HISTORIC AND DESIGN REVIEW COMMISSION

HDRC CASE NO: 2022-051
ADDRESS: 419 N MONUMENTAL
LEGAL DESCRIPTION: NCB 1373 BLK 1 LOT 33
ZONING: H
CITY COUNCIL DIST.: 2
DISTRICT: Dignowity Hill Historic District
APPLICANT: Manuel Almar/Manuel Almar
OWNER: Manuel Almar/Manuel Almar
TYPE OF WORK: Exterior modifications, addition, fenestration modifications, porch modifications, fencing
APPLICATION RECEIVED: January 12, 2022
60-DAY REVIEW: Not applicable due to City Council Emergency Orders
CASE MANAGER: Edward Hall

The applicant is requesting a Certificate of Appropriateness for approval to:

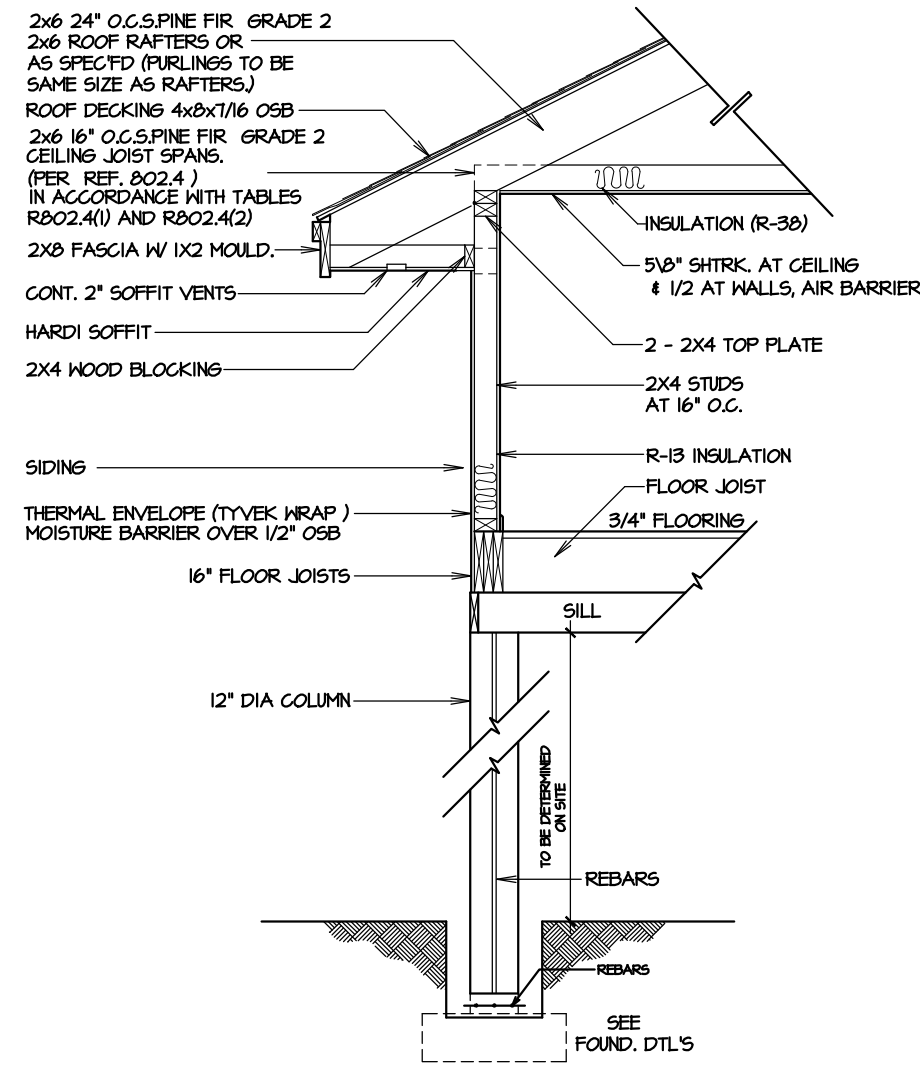
- f. PORCH FORM MODIFICATIONS – The applicant has proposed to remove the original porch form, which included a circular fascia with dentil molding. The existing front porch was enclosed with siding and windows; however, the original elements were still visible, as noted in the photos in the exhibits. While staff finds the return of the porch to an open porch to be appropriate, staff does not find the removal of the original fascia and architectural elements to be appropriate or consistent with the Guidelines. Staff finds that the original elements that were discarded should be reinstalled and that future porch restoration work should be consistent with the Guidelines for Exterior Maintenance and Alterations.

3. Staff does not recommend approval of item #3, porch roof modifications. Staff recommends that the historic porch form and porch roof form be preserved. All dentil molding and ornamental architectural element should be preserved and replicated. A sample mock up must be provided to staff to verify compliance.

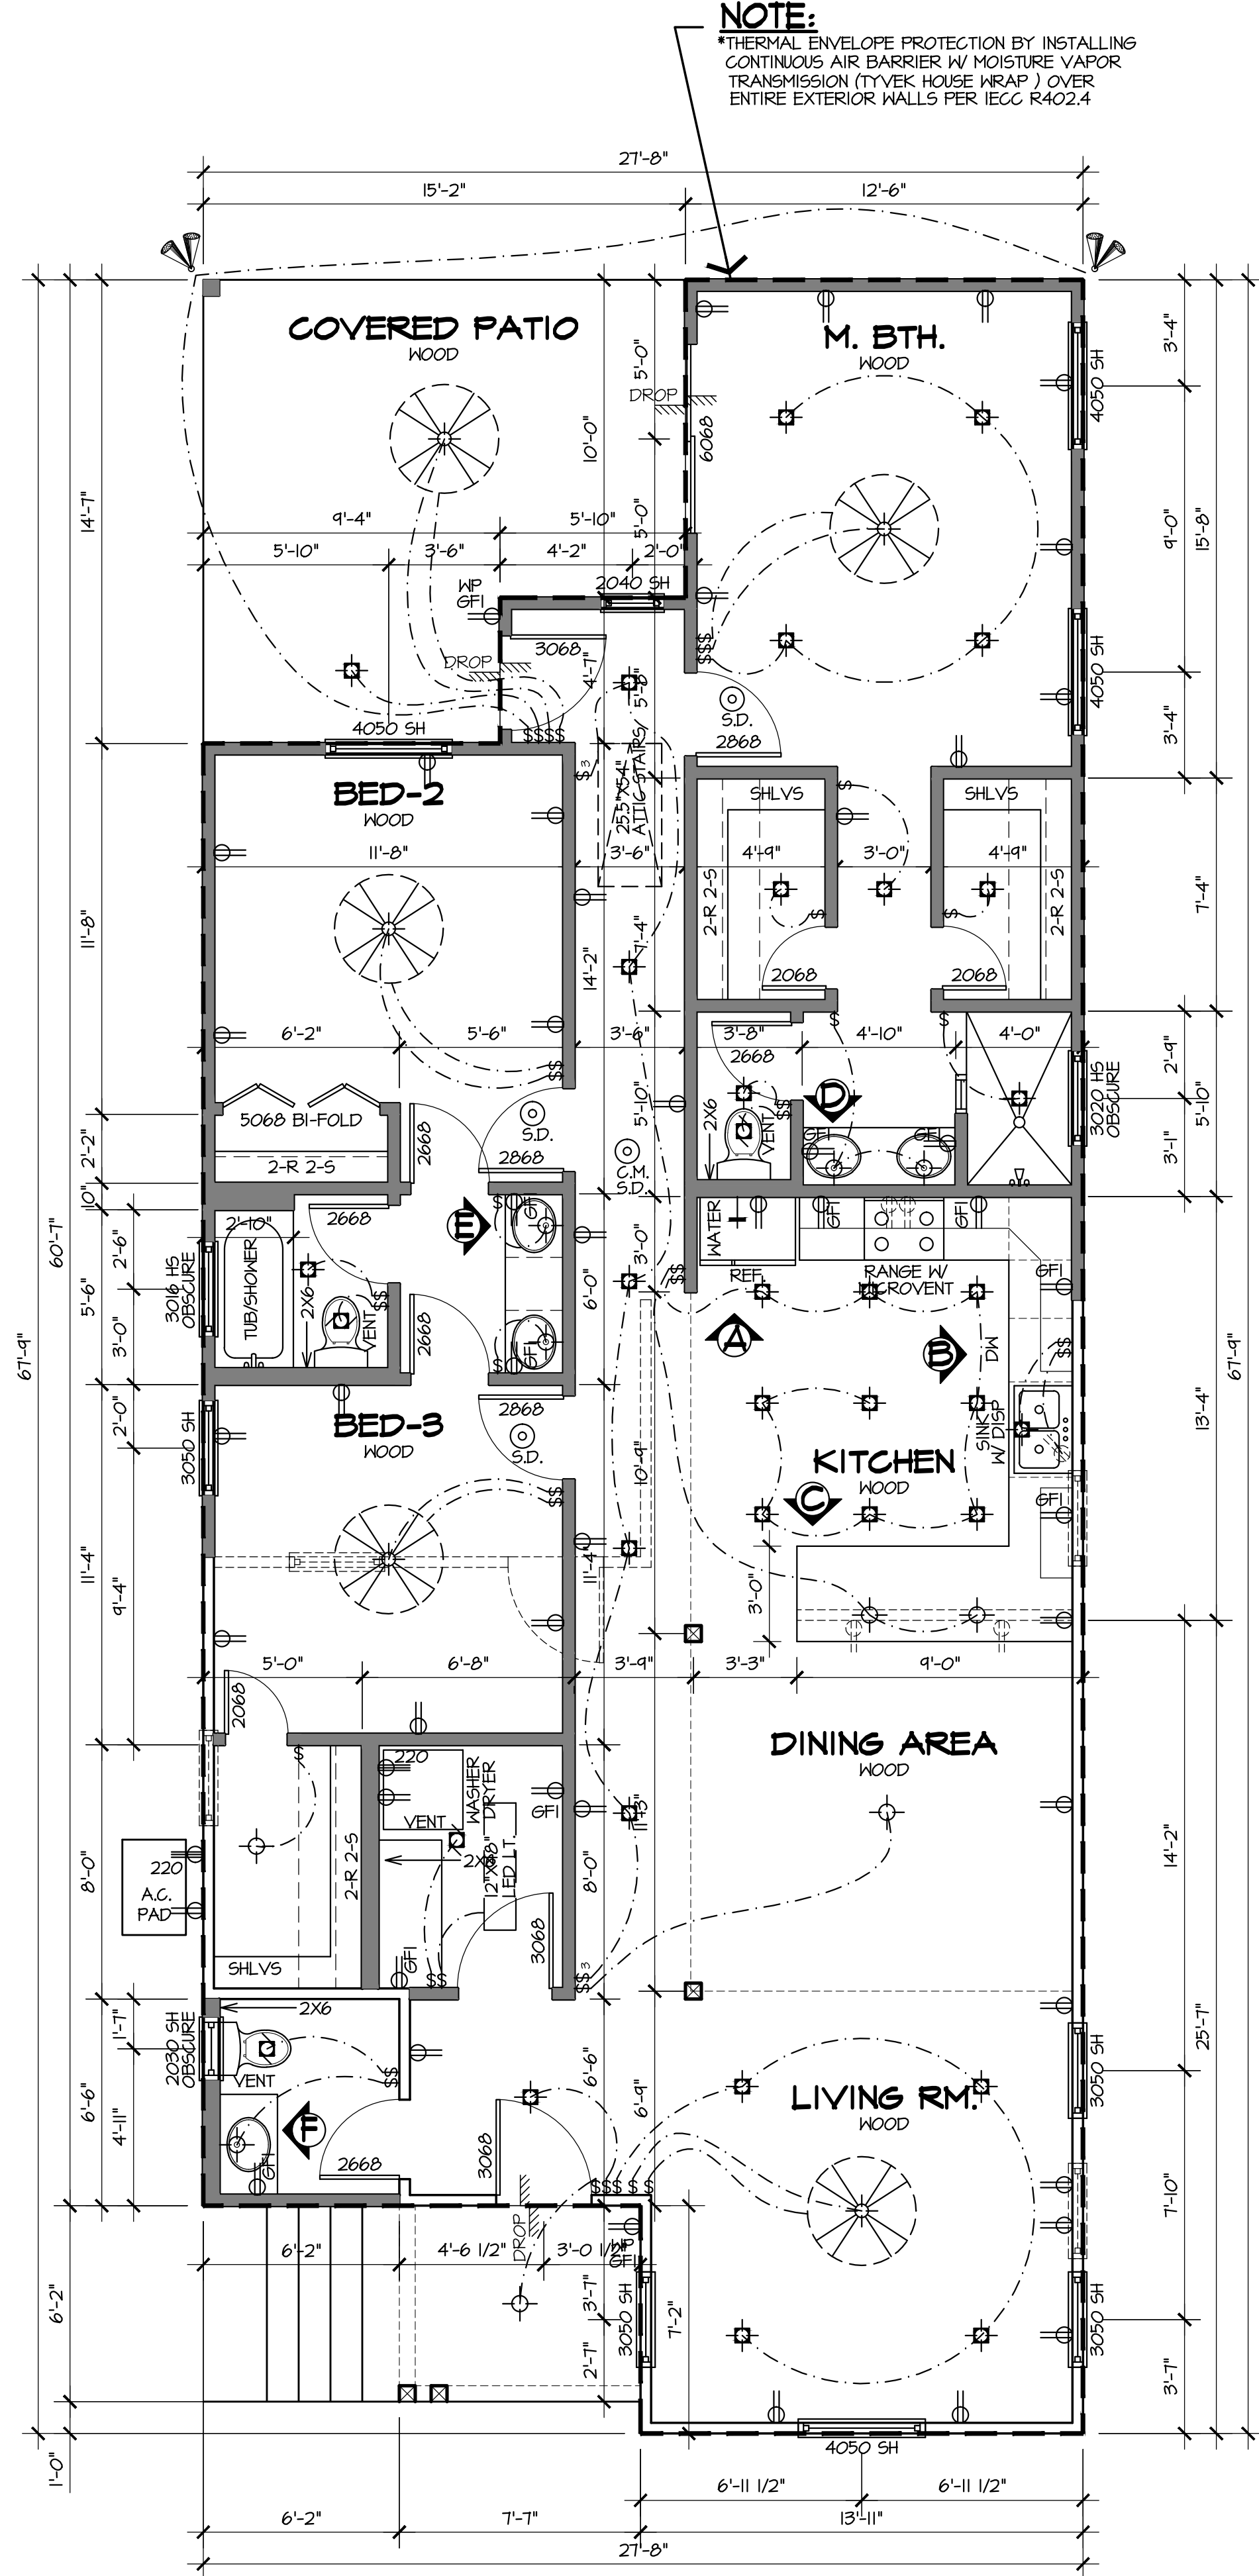
- h. REAR ADDITION – The applicant has proposed to construct a rear addition to feature approximately 900 square feet, including the rear patio space.
- i. REAR ADDITION – The Guidelines for Additions 1.A. notes that additions should be sited to minimize view from the public right of way, should be designed to be in keeping with the existing, historic context of the block, should feature similar roof forms, and should feature a transition to differentiate the new addition from the historic structure. Additionally, the Guidelines for Additions 1.B notes that additions should be subordinate to the principal façade of the historic structure, should feature a footprint that responds to the size of the lot, and should feature an overall height that is generally consistent with that of the historic structure. Generally, staff finds the proposed addition to be inconsistent with the Guidelines. Staff finds that the proposed addition should be subordinate to the primary historic structure regarding footprint, massing, height, and roof form. The proposed addition should adhere to the Guidelines for Additions.

- l. ARCHITECTURAL DETAILS – As noted in finding i, staff finds that the overall massing of the addition should be reduced, and that the addition should feature a subordinate ridge line and an offset in wall planes or a detail to differentiate the addition from the historic structure's massing. Staff finds that all window openings should be consistent with the Guidelines, and that contemporarily sized windows should be eliminated for traditionally sized windows.

5. Staff does not recommend approval of item #5, the construction of a rear addition based on findings h through l. Staff recommends that the addition feature a footprint, massing, roof form, materials and architectural details, including fenestration profiles that are consistent with the Guidelines for Additions.

FRONT ELEVATION

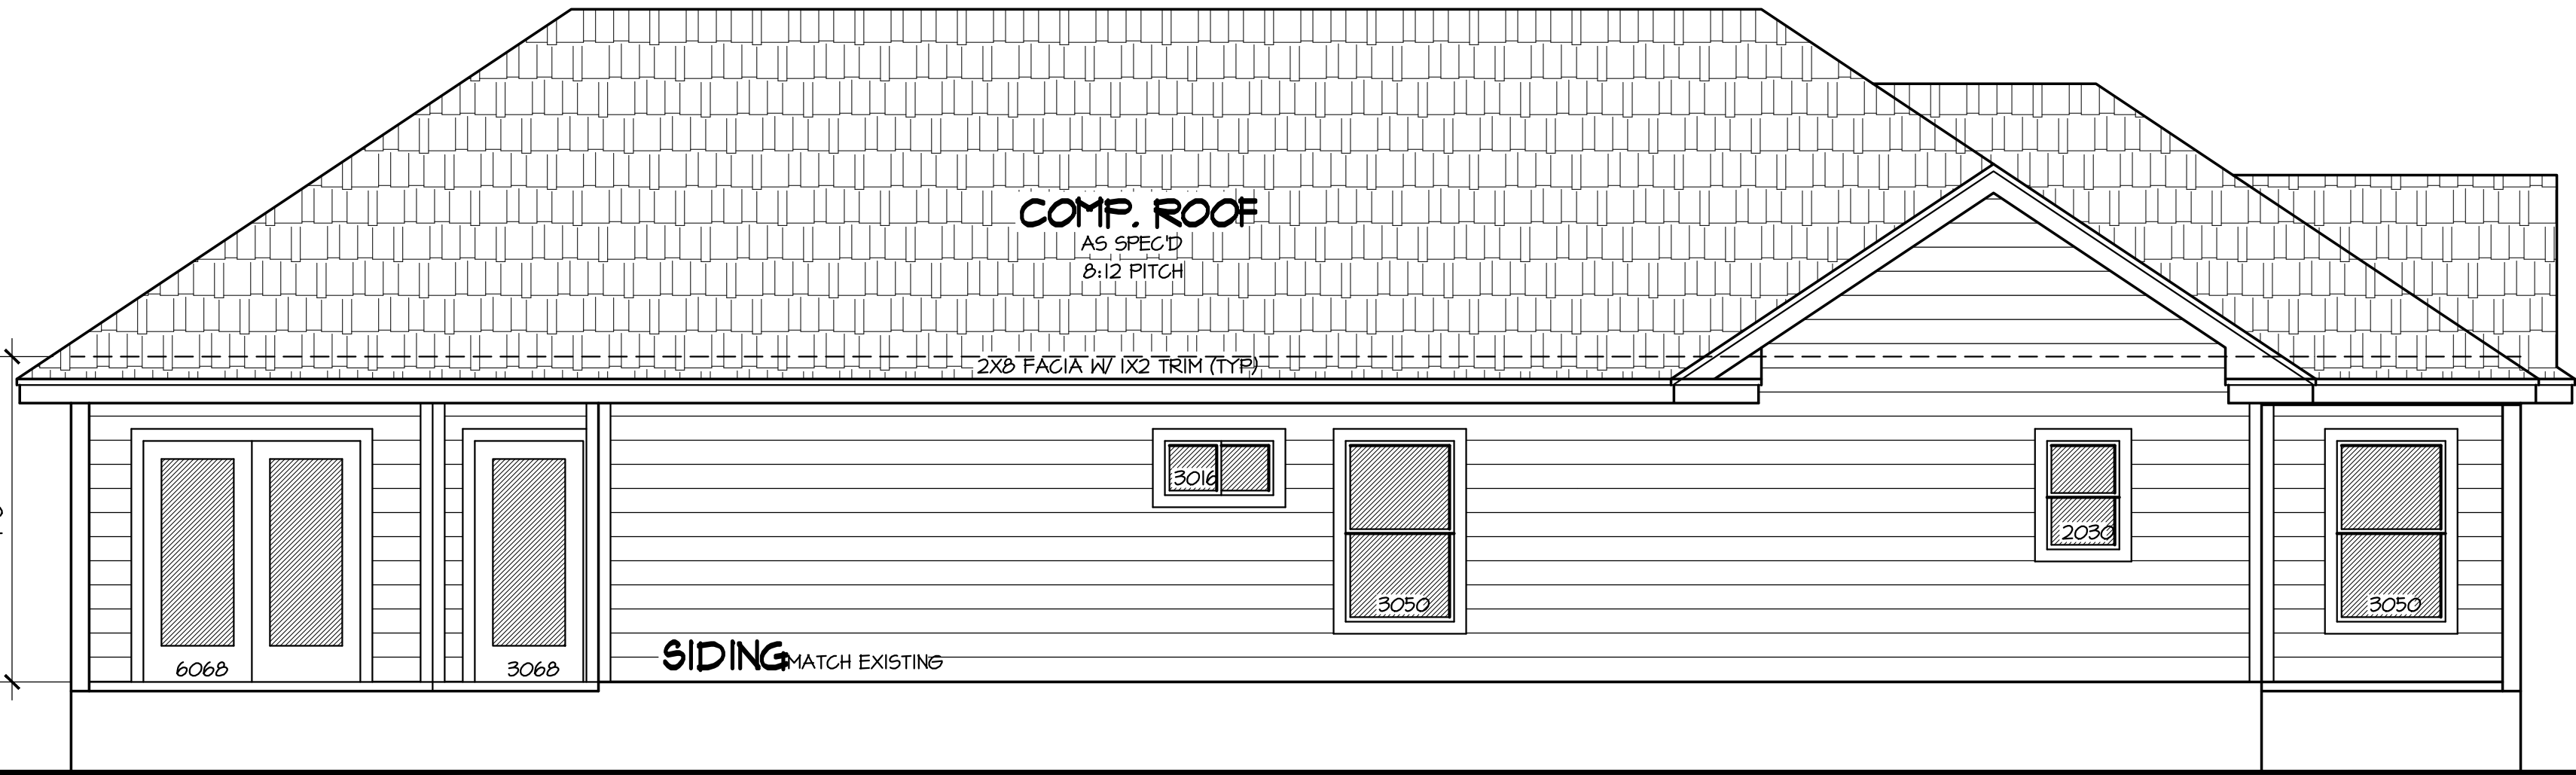
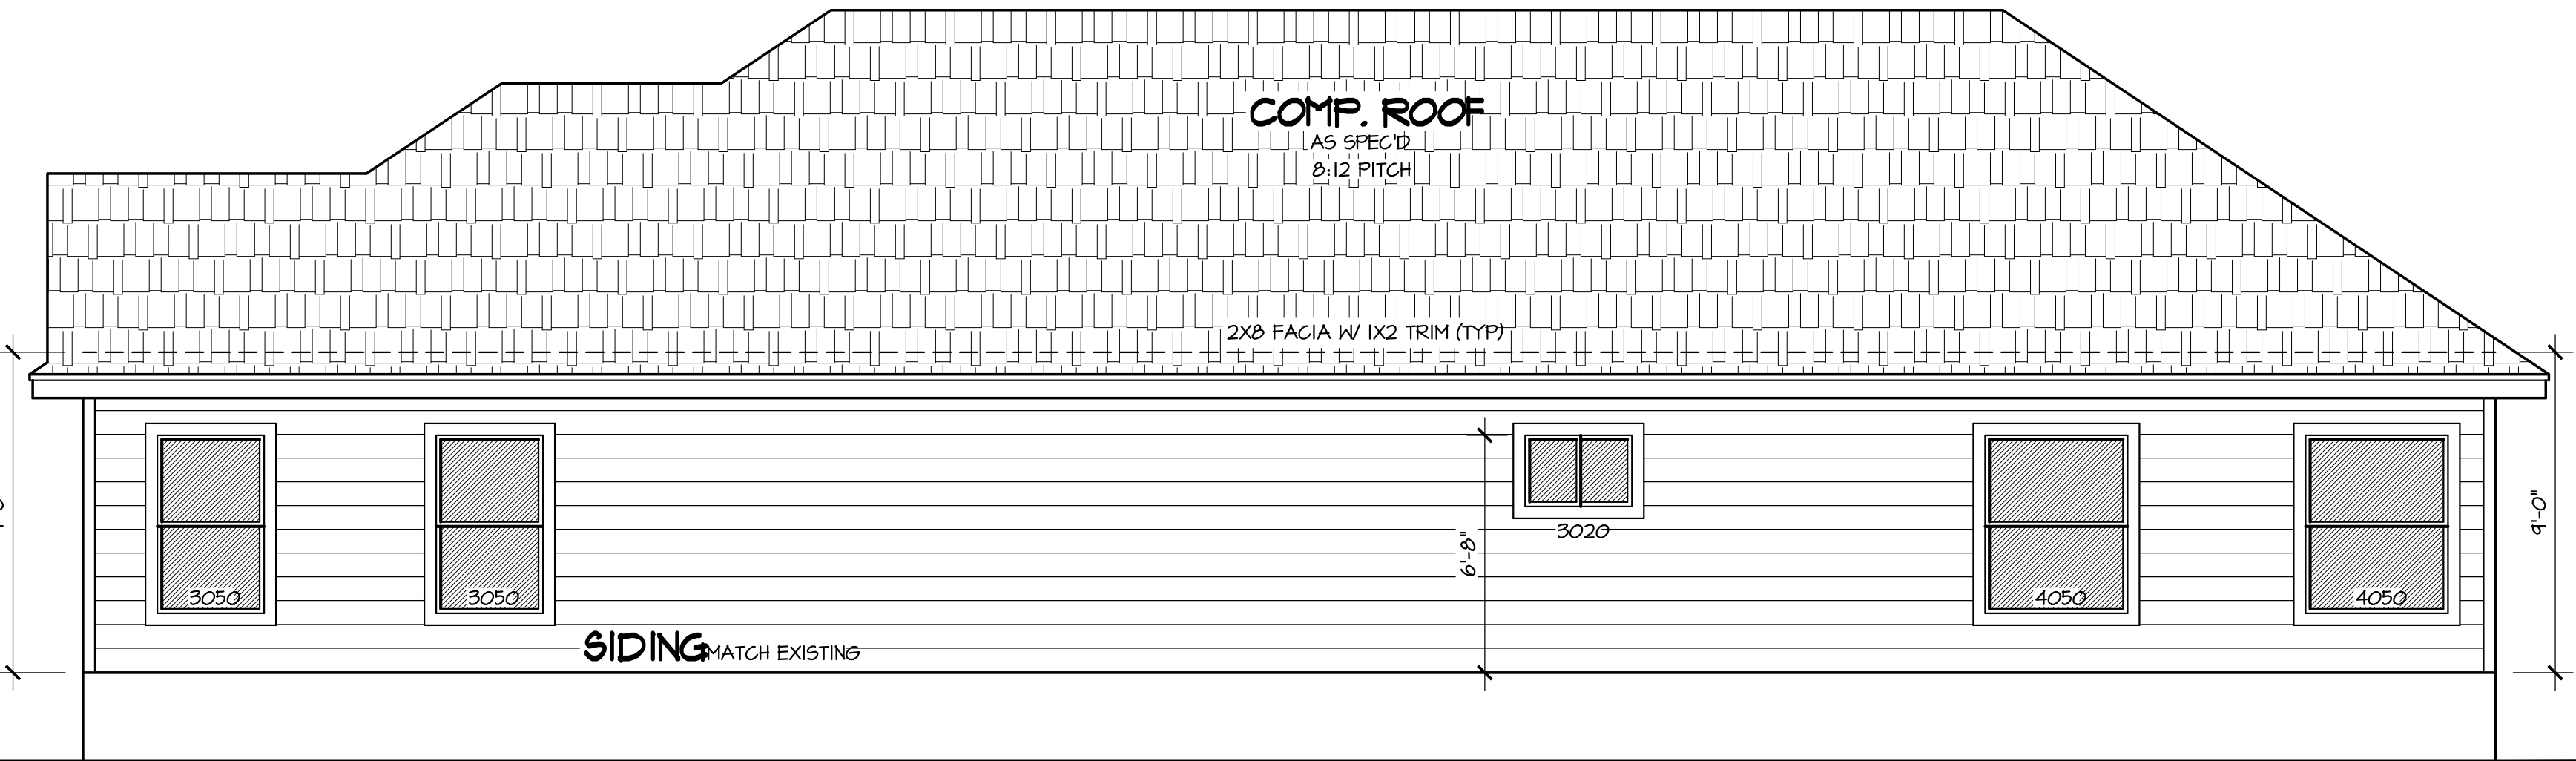
- g. FENESTRATION MODIFICATIONS – The applicant has proposed fenestration modifications that include modifications to existing openings on the front façade, to include both window and door openings, as well as the removal of existing window openings on the north and south facades and the creation of new openings in their place. The Guidelines for Exterior Maintenance and Alterations 6.A.i. notes that existing window and door openings should be preserved. Staff finds the proposed fenestration modifications to be inappropriate and inconsistent with the Guidelines.

4. Staff does not recommend approval of item #4, fenestration modifications, based on finding g. Staff recommends that all existing window and door openings be preserved.

ROOF PLAN

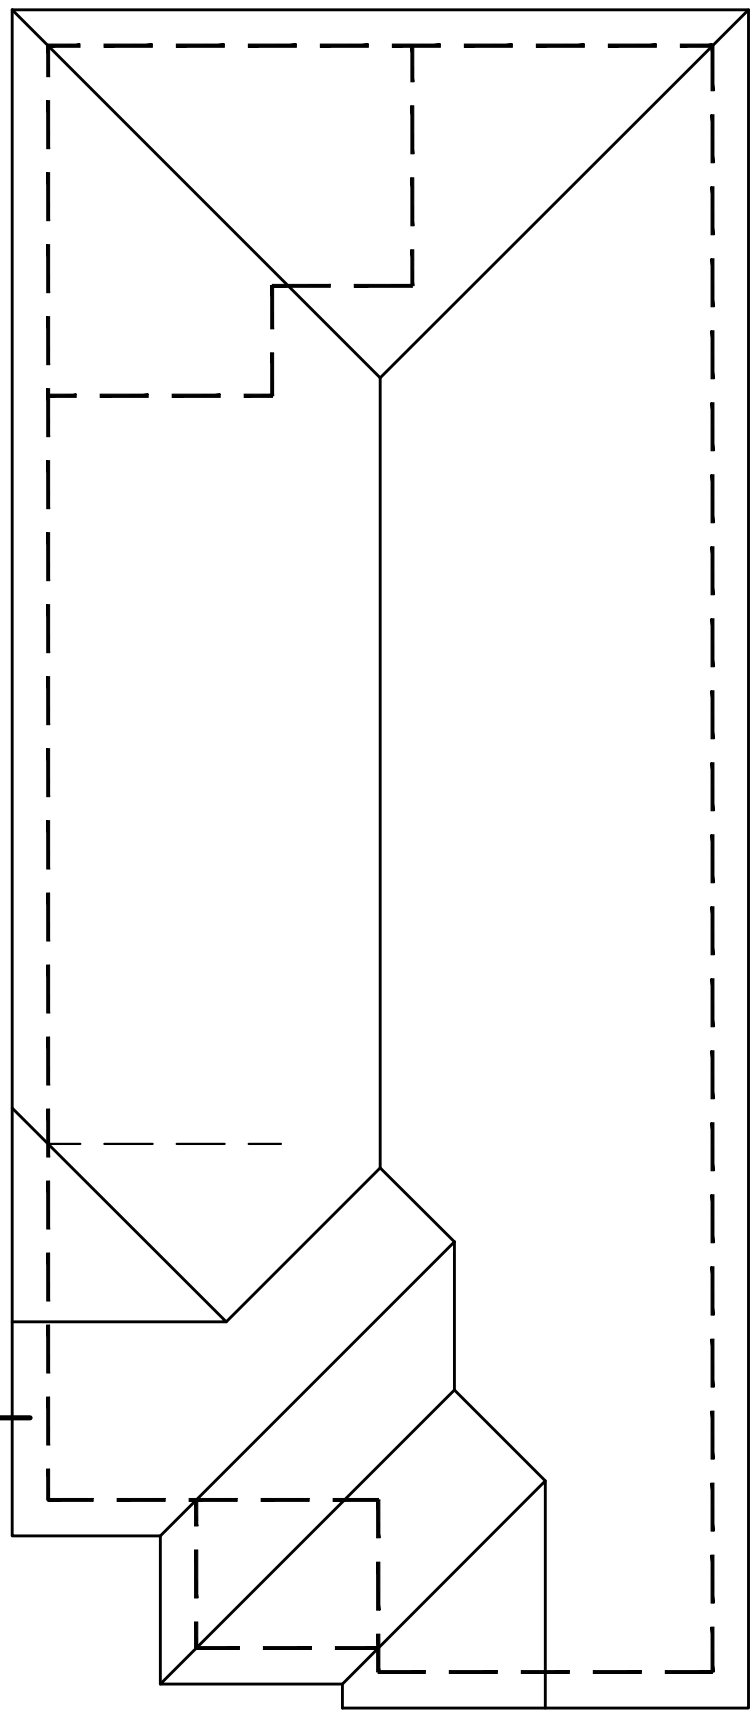
- d. ROOF REPLACEMENT – The applicant has proposed to replace the existing, shingled roof with a new shingled roof. Staff finds the proposed replacement to be appropriate provided that all original roof forms and architectural details associated with the original roof form are preserved.

1. Staff recommends approval of item #1, roof replacement based on finding d with the stipulation that all original roof forms and architectural details are preserved.
